PRODUCTION CHANGE SHEET
FOR
POWER SUPPLY MODEL 4EP14B2
PL-19C300200-G1(PS) - REV. H
PL-5494787-G5 (HEAT SINK)

The changes listed below are identified by the REV. letter appearing after the unit model number.

REV. A. CIRCUIT

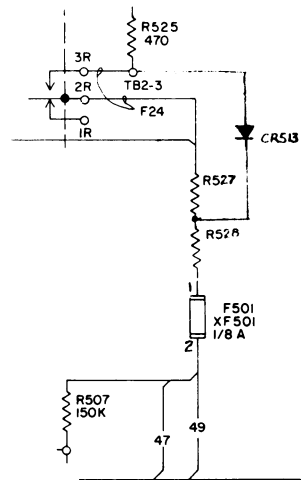
REV. A (PL-19C300200-G1)

To improve the Receiver B-plus regulation under duplex condition.

<u>Part Changed</u>	<u>Was</u>	<u>Changed To</u>
CR513	Added.	Silicon: Half-wave rectifier, hermetically sealed in metal container (glass insulated). Sim. to G-E 1N1695. Sim. to Westinghouse Electric 1N1169. G-E Part No. 5490415-P2.
R527	Added.	Wirewound; 750 ohms $\pm 10\%$, 5 w. Sim to G-E Part No. 7487415-P129.
R528	Added.	Composition, 10 ohms $\pm 10\%$, 1/2 w sim to G-E Part No. 3R77-P100K.

Mechanical: Redesign of component board PL-19C300356-G1

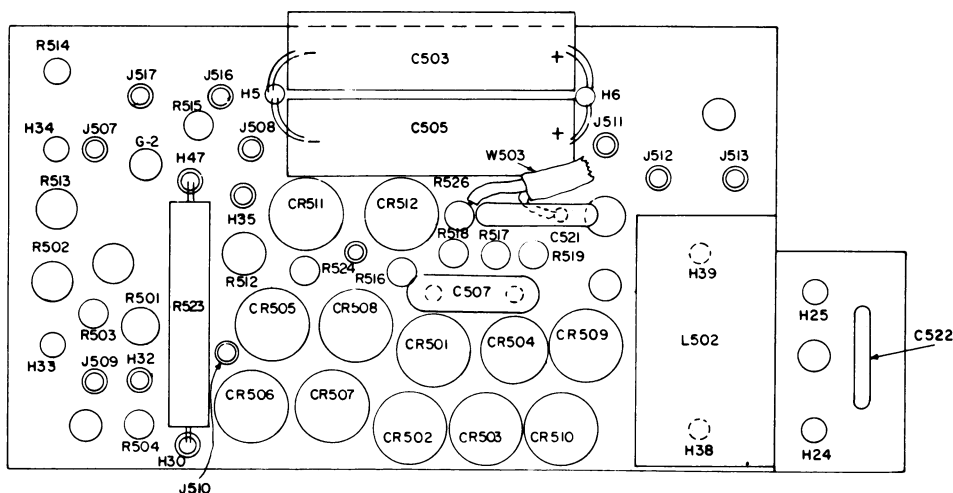
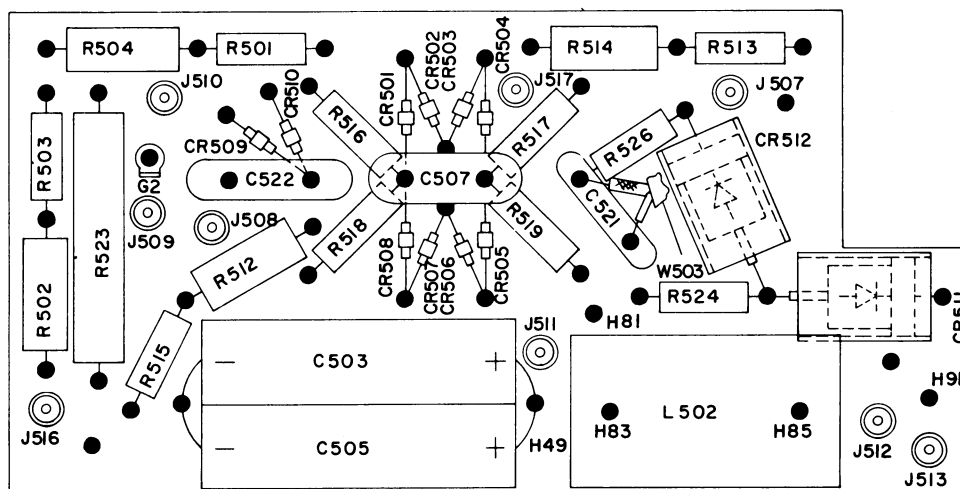
To improve mechanical design by replacing diodes CR501 through CR510 with smaller components and changing the component layout.

<u>Symbol</u>	<u>Was</u>	<u>Changed To</u>
CR501 thru CR510	Rectifier, silicon; sim to G-E Part No. 5490415-P2.	Rectifier, silicon; sim to G-E Part No. 4037822-P1.

REVISION G CIRCUIT

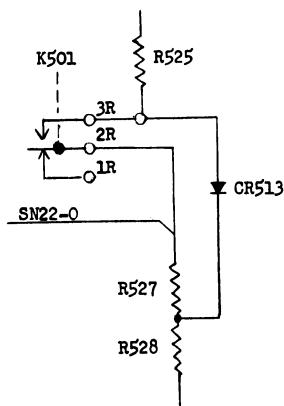
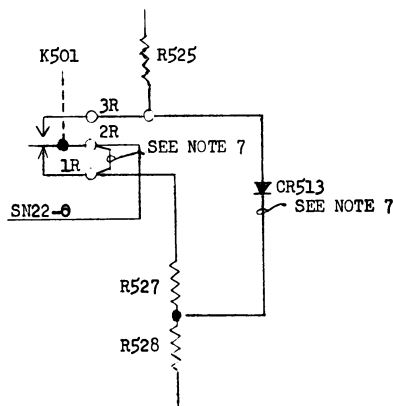
- CHANGES - 1. L506 (added by REV. F) was removed L502 was changed from a 120 uh choke to a 30 uh choke.
2. A diode, CR514, was connected from K501-S to K501-F to reduce the possibility of arcing in the keying contacts of the Push-to-talk relay (K50) in the Supervisory Signaling Unit.
3. Receiver B+ connections to K501 changed (see Wiring Diagram Changes).

NOTE 7. FOR SIMPLEX OPERATION CLIP OUT CR513 AND JUMPER BETWEEN K501-1R AND 2R.
